**BEFORE INDEPENDENT COMMISSIONER WELLINGTON CITY COUNCIL**

In the matter of A Resource Consent for the construction and operation of an extend carpark to Foodstuffs New World, Khandallah, Wellington

**STATEMENT OF EVIDENCE  
Edward Xavier Dyer**

**Wellington City Council  
NOISE & ACOUSTICS**

Figure 2: MDA noise assessment – acoustic barrier

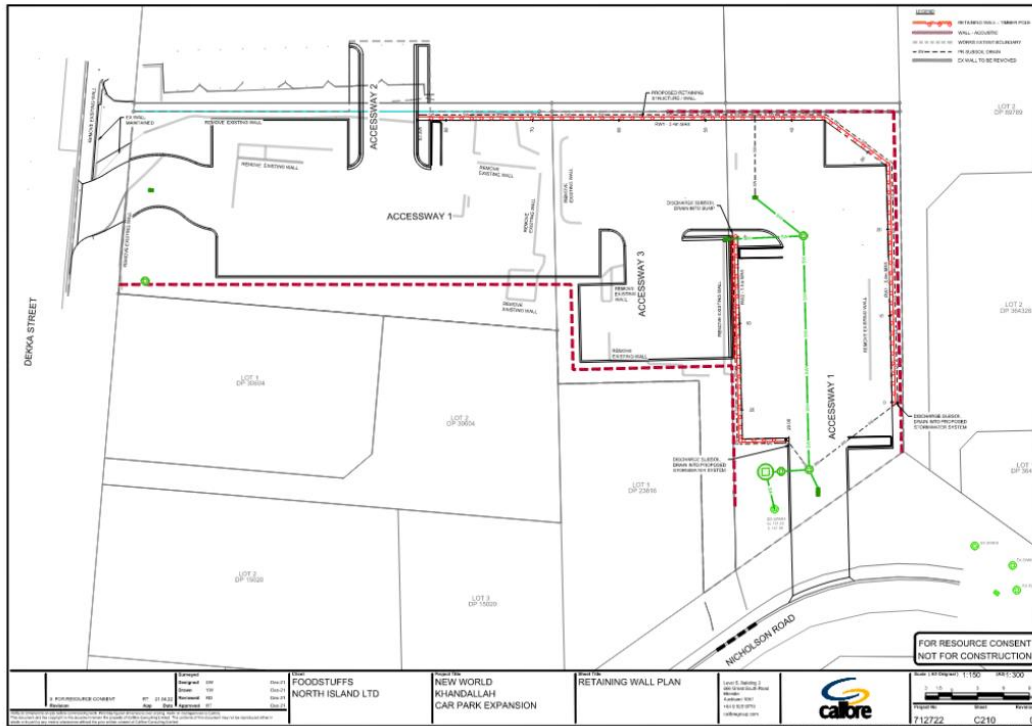
21 The MDA review notes there is currently no specific noise mitigation on the site however new noise protection walls (noise barrier fencing) around the perimeter of the site is proposed, the proposed noise barrier is shown in Figure 2 and Figure 3 of the MDA review.

25 The MDA report notes all noise walls are proposed to be at least 1.8 metres high and constructed with no air gaps between panels and between the fence and the ground i.e a noise fence. The minimum surface mass should be  $12 \text{ kg/m}^2$ .

26 The MDA response to further information review also notes that a reduction of the noise barrier of up to 14 dB has been applied for ground floor receivers and 3 dB for first floor receivers. We assumed the MDA assessment is based on this minimum 1.8m high barrier as this is the height shown in the MDA report (Figure 3 acoustic barrier design). I note that a typical wooden grade acoustic fence at 1.8m is generally expected to reduce noise between 8-10 dB (for ground floor receivers). A reduction at ground level of 14 dB is achievable however it is not clear how the final fence design and specifications will achieve this level; the Applicant’s noise advisor should provide further comment on this and how 14 dB will be achieved.

observation as MDA has relied on a 3dB reduction. The Applicant's noise advisor should provide further comment on this matter also for each specific receiver site.

Prior to the completion and construction of the perimeter acoustic design barrier fence the consent holder must submit to the Council's Compliance Monitoring Officer an Acoustic Design Certificate (ADC) for the acoustic barrier fence. This certificate must certify that a site inspection has taken place and that the final constructed acoustic fence is sufficient to ensure noise emitted from the car park area complies with the following noise limits:
